Detailed Site Plan
Departure from Parking and Loading Spaces
College Park Marriott

DSP-18047
DPLS-485

STAFF REPORT

SUBJECT: Detailed Site Plan DSP-18047
Departure from Parking and Loading Spaces DPLS-485
College Park Marriott

MATERIAL LEGEND

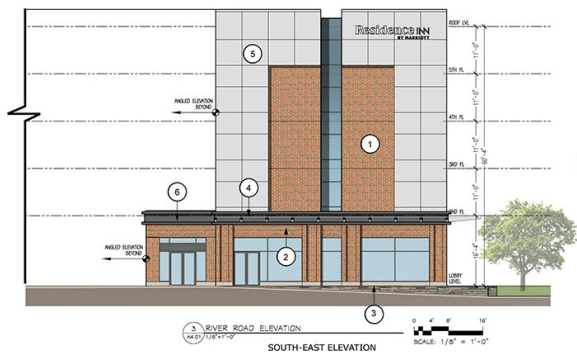
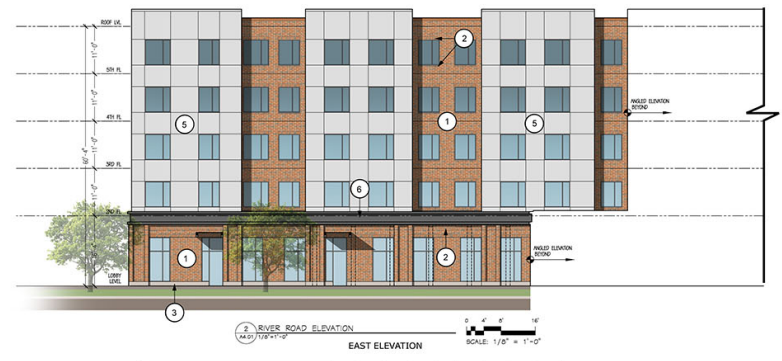
- g. Show full screening of the loading space in the rear of the building on all plans.
- h. Revise the architectural plan and details to show the location and materials of the trash enclosure, and include a note stating that all retail windows shall be clear glass.

- q. Provide additional windows or architectural articulation on the ground-floor wall of the elevation facing Lehigh Road, in order to enhance visual interest and to activate the street, to be reviewed and approved by the Urban Design Section as the designee of the Prince George's County Planning Board.

MID-RISE PYLON

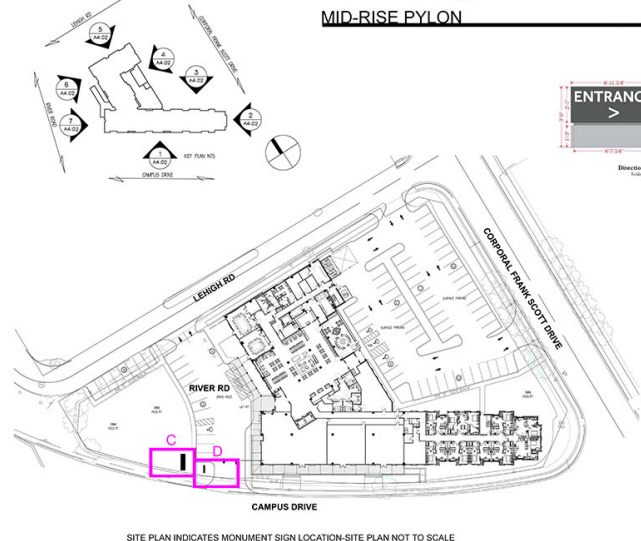
- t. Remove the freestanding and monument sign from all plans.
2. Prior to approval of any permits, the applicant is required to obtain from the Prince George's County Department of Parks and Recreation a Construction and Maintenance Agreement for construction and maintenance of the compensatory storage on parkland (at College Park Airport) and a Floodplain Compensatory Storage Easement from The Maryland National Capital Park and Planning Commission.
